WATER PERMIT NO. 5882-3

PROJECT: BOLSTAD WPA
SD-0177-001

Water Permit Application #5882-3
USFWS
Bolstad WPA

REPORT ON
WATER PERMIT APPLICATION NO. 5882-3
US Fish and Wildlife Service
September 13, 1995

FIGURE 2

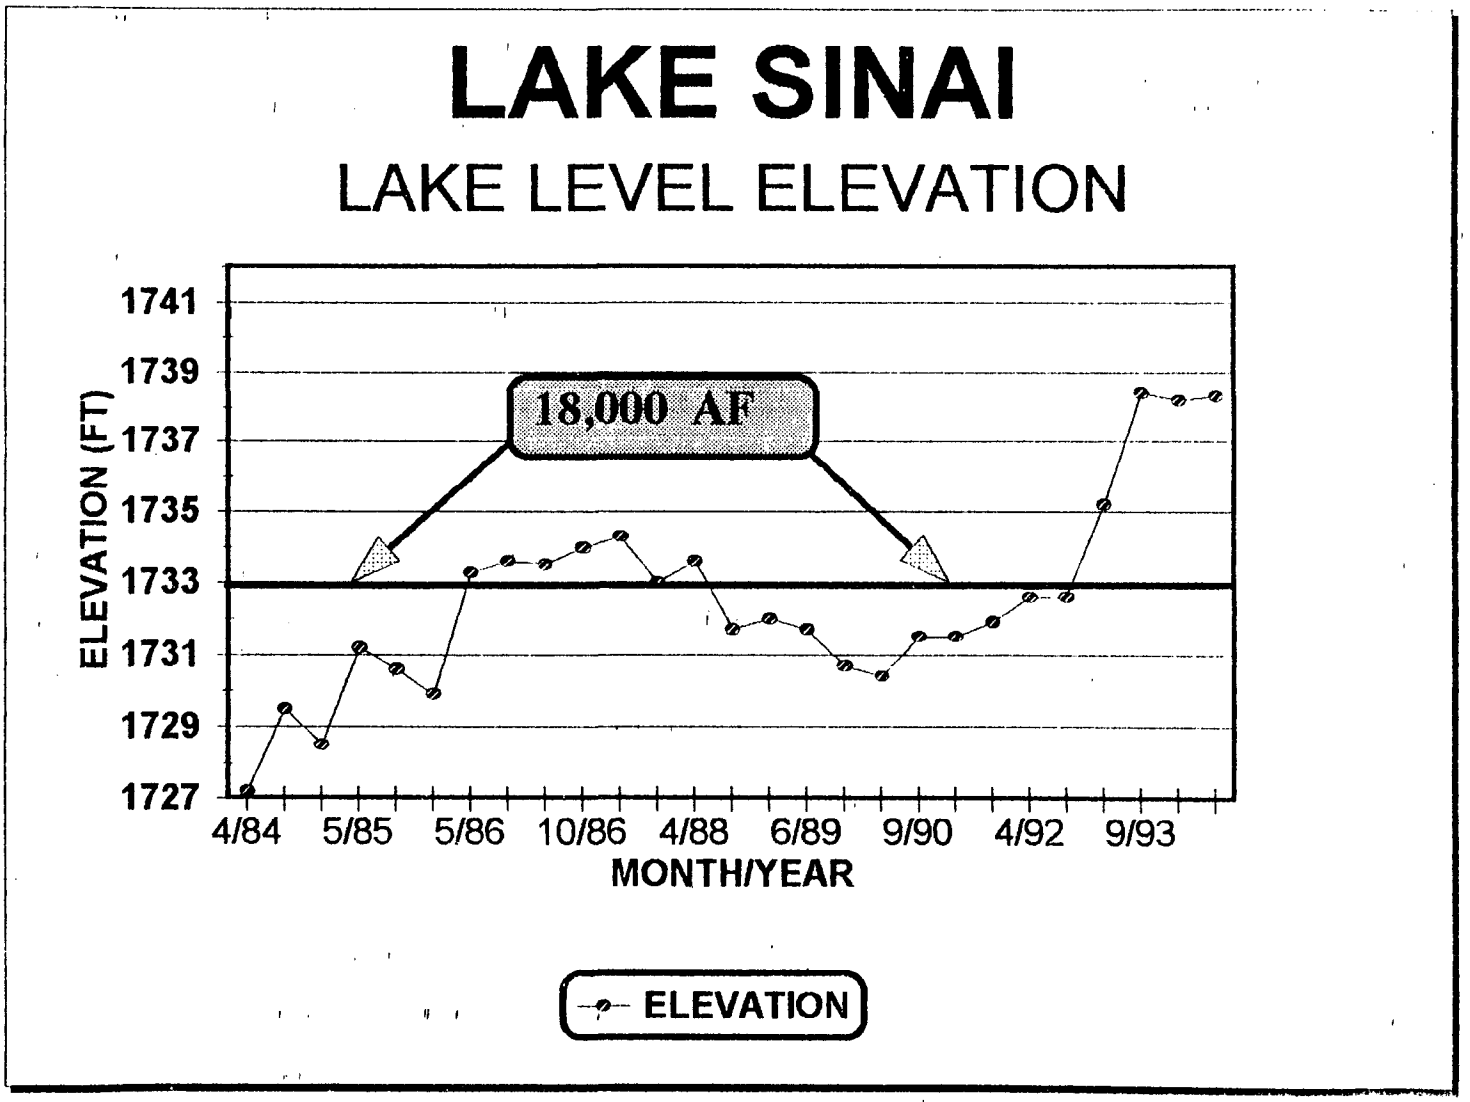
There is an error in my Report on Water Permit Application No. 5882-3 for the US Fish and Wildlife Service. The storage in Lake Sinai authorized by Vested Water Right Claim No. 897-3 should be 1,800 acre-feet NOT 18,000 as mentioned in the report.
